# SUBJECT: SOUTH TEXAS PROJECT ELECTRIC GENERATING STATION - NRC SPECIAL INSPECTION TEAM REPORT 05000498/2003008 AND 05000499/2003008 AND EXERCISE OF ENFORCEMENT DISCRETION

Dockets:	50-498 50-499	
Licenses:	NPF-76 NPF-80	
Report No:	05000498/2003008 05000499/2003008	
Licensee:	STP Nuclear Operating Company	
Facility:	South Texas Project Electric Generating Station, Units 1 and 2	
Location:	FM 521 - 8 miles west of Wadsworth Wadsworth, Texas 77483	
Date:	May 5 through July 28, 2003	
Inspectors:	R. Bywater, Senior Reactor Analyst (Team Leader) N. O'Keefe, Senior Reactor Inspector W. Sifre, Reactor Inspector M. Runyan, Senior Reactor Analyst M. Mitchell, Senior Materials Engineer, NRR	
Accompanying Personnel:	S. Doctor, Ph.D., Consultant	
Approved By:	D. Chamberlain Acting Deputy Regional Administrator

Figure 2

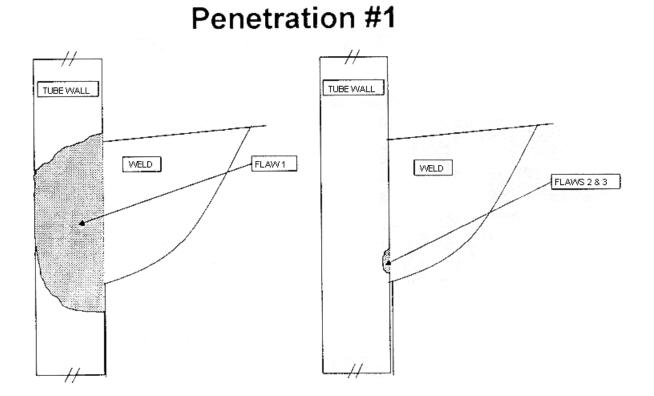
The results from BMI Penetration 1 are depicted in Figure 2. Three axially-oriented crack-like indications were identified in the nozzle wall. One of the indications was characterized as an axial crack with a length of about 1.38 inches, surface breaking on the OD of the nozzle above and below the J-groove weld, as well as surface breaking on the ID of the nozzle. The ID surface breaking nature of this flaw was confirmed by the ET examination. The OD surface breaking nature of this flaw was confirmed by the helium gas test. The other two indications were characterized as being small, embedded (i.e., non-surface breaking) cracks near the interface between the nozzle wall and the root pass of the J-groove weld.

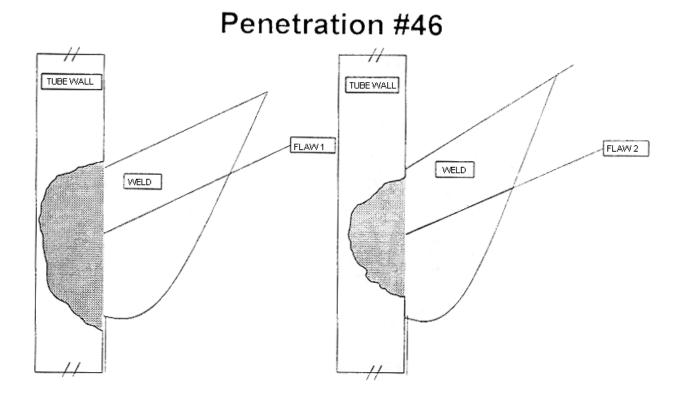
The results from BMI Penetration 46 are depicted in Figure 3. Two axially-oriented crack-like indications were identified in the nozzle wall. One of the indications was characterized as an axial crack with a length of about 0.98 inches, surface breaking on the OD of the nozzle above and below the J-groove weld. The surface breaking nature of this flaw was unable to be confirmed by the helium gas test. The flaw was not found to be surface breaking on the ID of the nozzle by the ET examination. The other indication was characterized as an embedded crack having an axial length of 0.95 inches.

# Half-Nozzle Repair

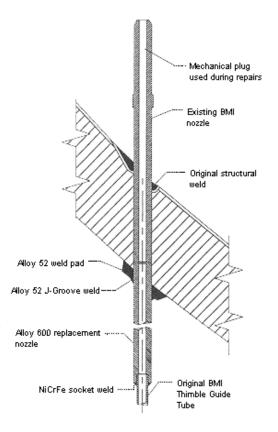
Upon the discovery of the deposits around STP, Unit 1, BMI Penetrations 1 and 46, the licensee began the process of designing a potential repair option. The licensee developed a "half-nozzle" repair which was similar in design to those which had been implemented at other facilities for the repair of cracked pressurizer heater penetrations, RCS instrumentation penetrations, etc. This repair option was chosen and characterized as a permanent repair of STP, Unit 1, BMI Penetrations 1 and 46. A cross-section of the repair design is shown in Figure 4. The essential elements of the repair design were as follows:
